Access Compliance Report to accompany a

Development Application

Development Address: 32-36 Hope Street, Penrith NSW

Client: Design Corp Architects Pty Ltd

Basement 1 shown below

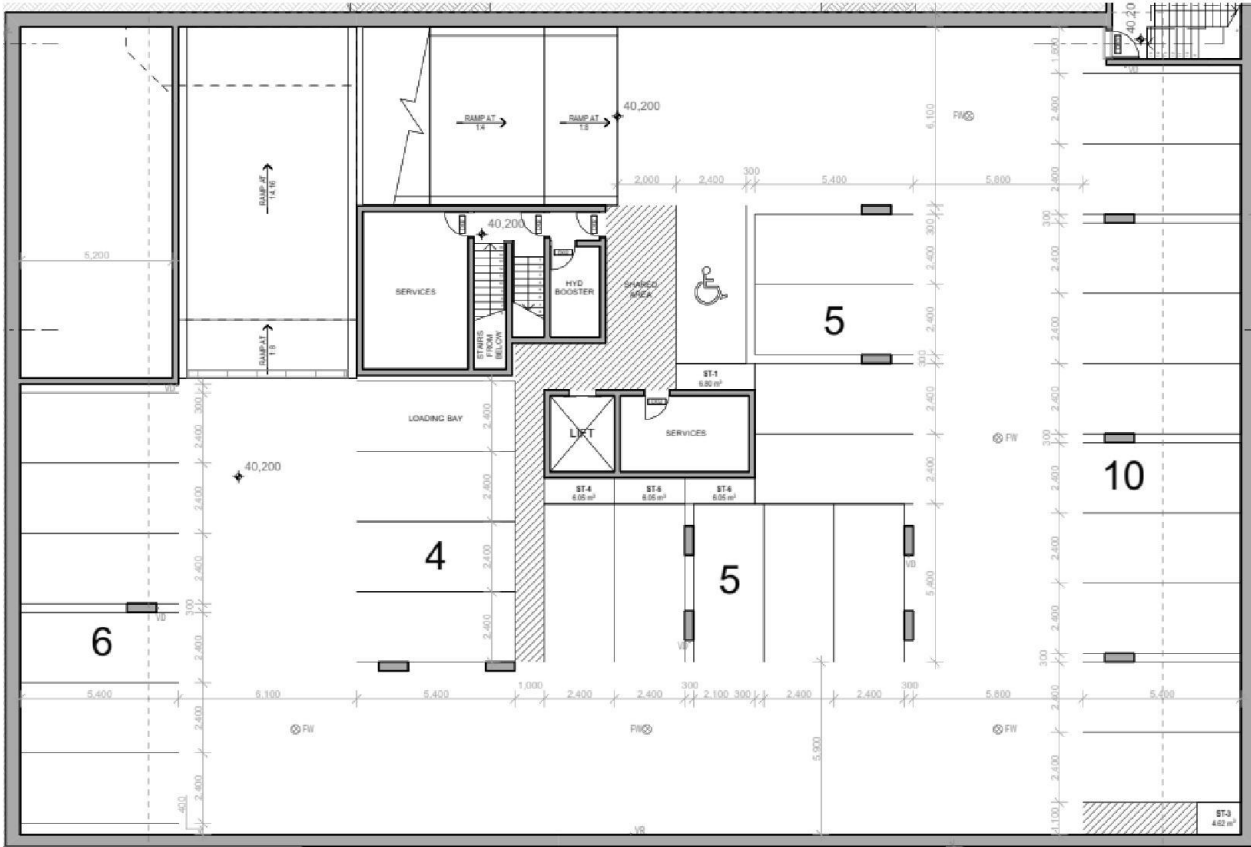
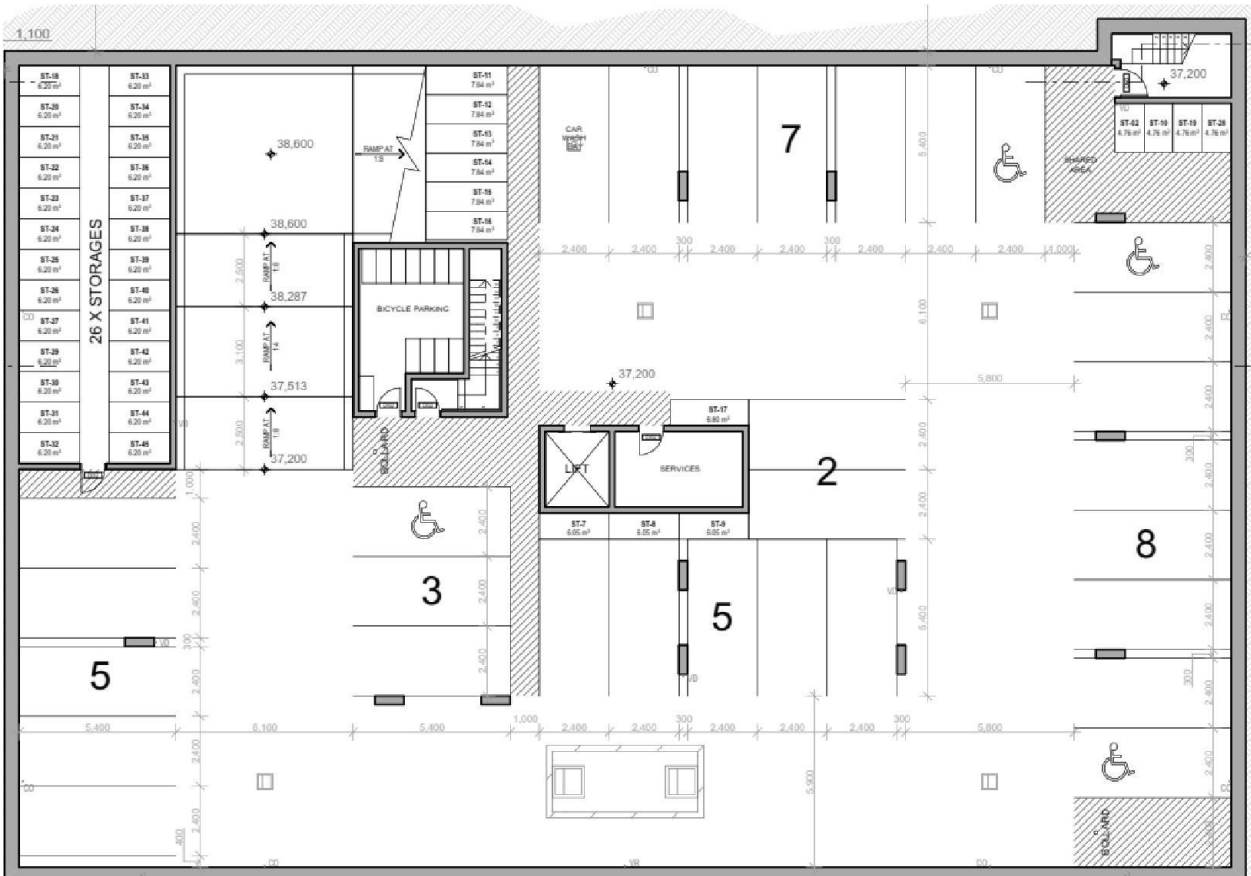
BCA Part D3.5 Accessible Carparking	
Requirement	Class 2 There are no Accessible carparking requirements for a Class 2 under the BCA. If adaptable housing has been mandated by the Council, then carparking spaces for Adaptable units will be required under the requirements of AS4299- Adaptable housing.
Compliance Comments	Complies. Penrith Council requires provision of 10% Adaptable units in the development. Development has total number of 45 units. 10% of 43 = 5 required Adaptable units. Therefore 5 accessible compliant carparking spaces are required for the residential component of the development. 5 Accessible compliant car parking spaces have been provided in development. One accessible compliant parking space is required to be allocated to each of the Adaptable units. Detailed features of the accessible/ adaptable parking spaces are to be verified at CC stage of works.

Pre and post adaptation layouts of Unit 02 shown below

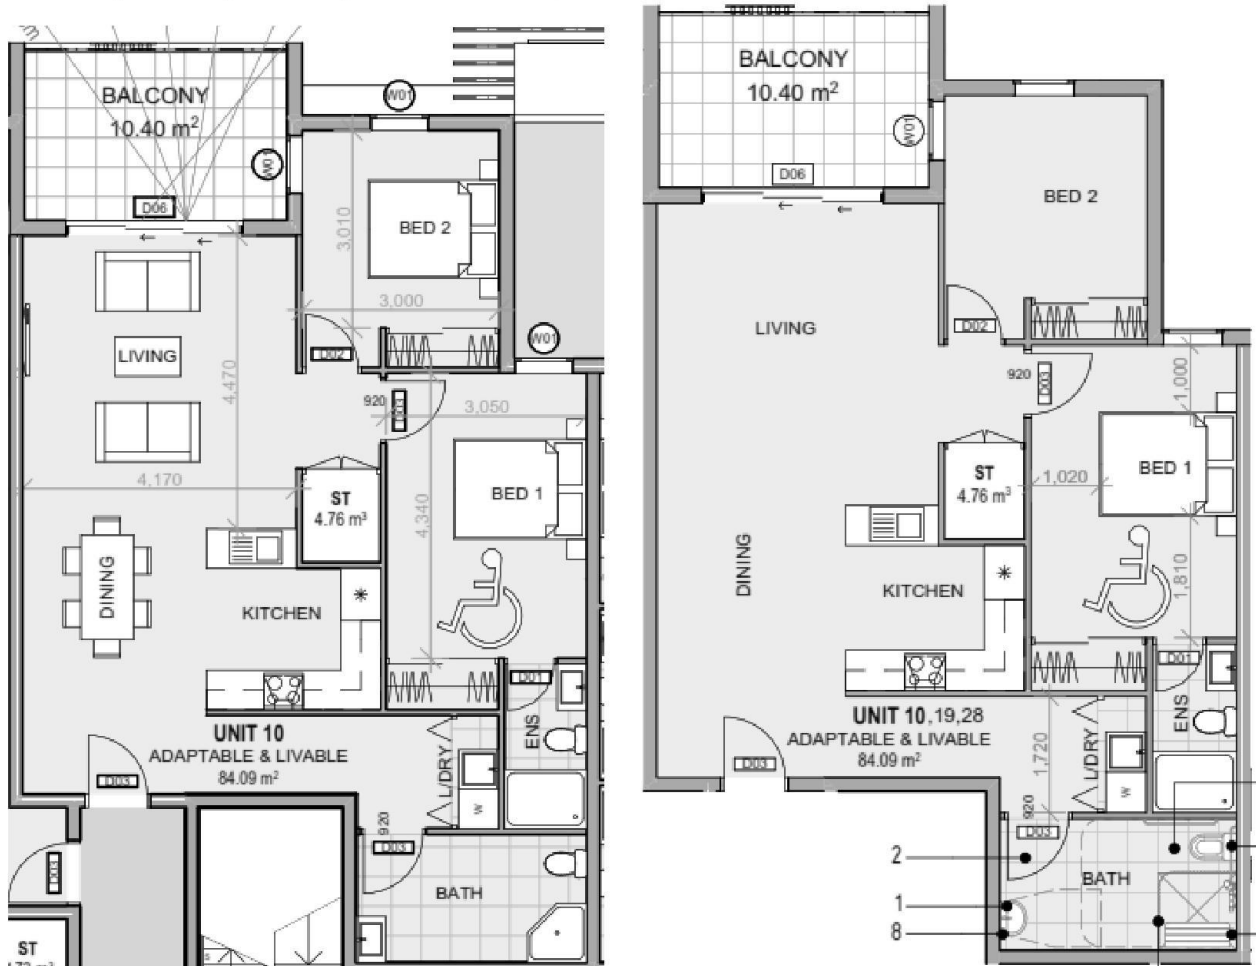
The location of the WC pan can be in the same location at post adaptation

Unit 42

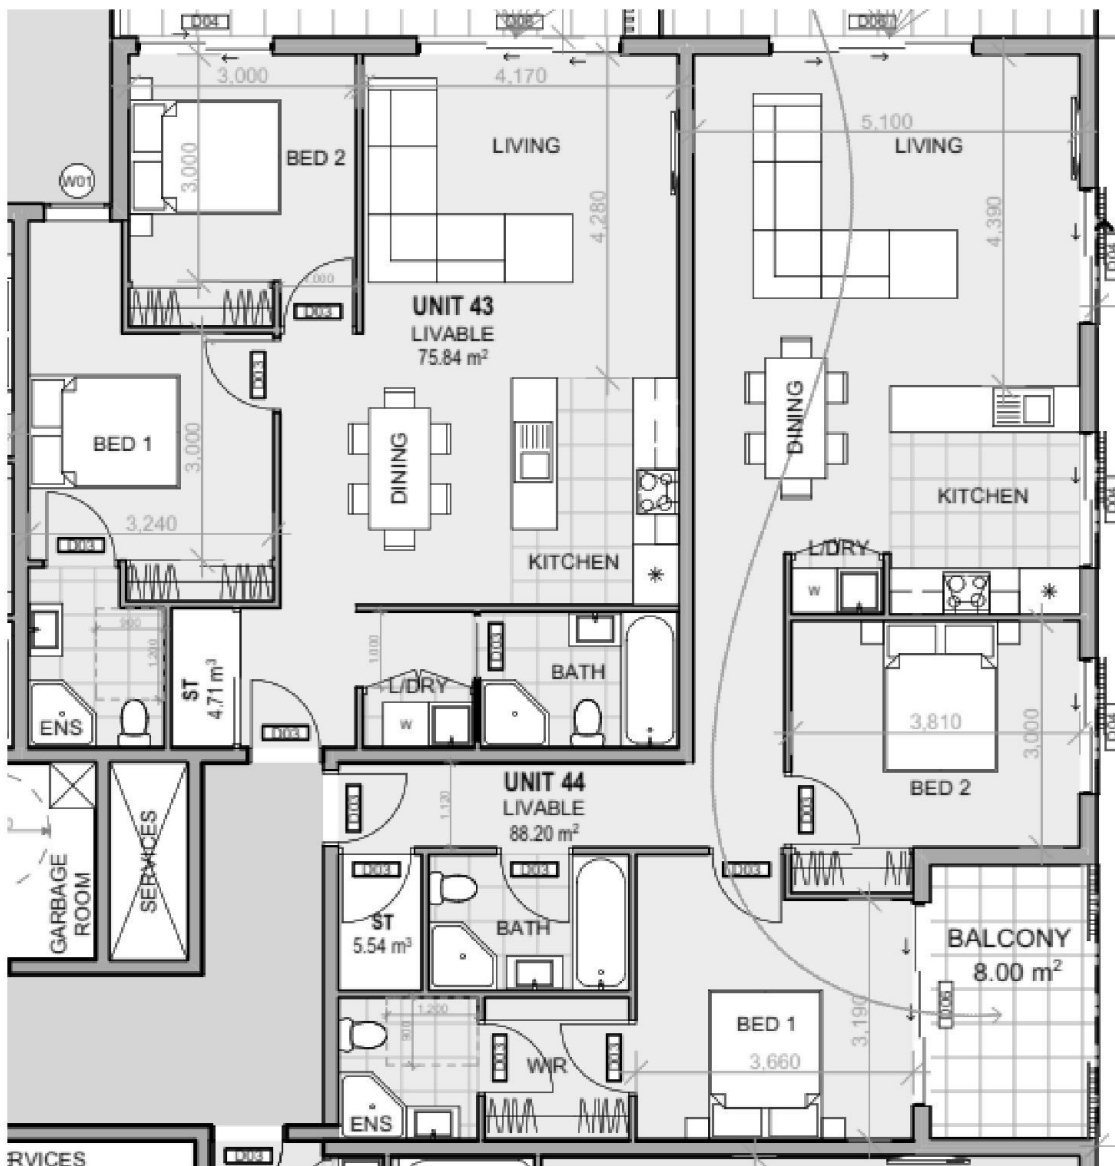
In addition to the adaptable units provided the following 4 units **42, 43, 44 and 45** are capable of providing compliance with the features of Silver level of Livable Housing Guidelines as noted in the table below.
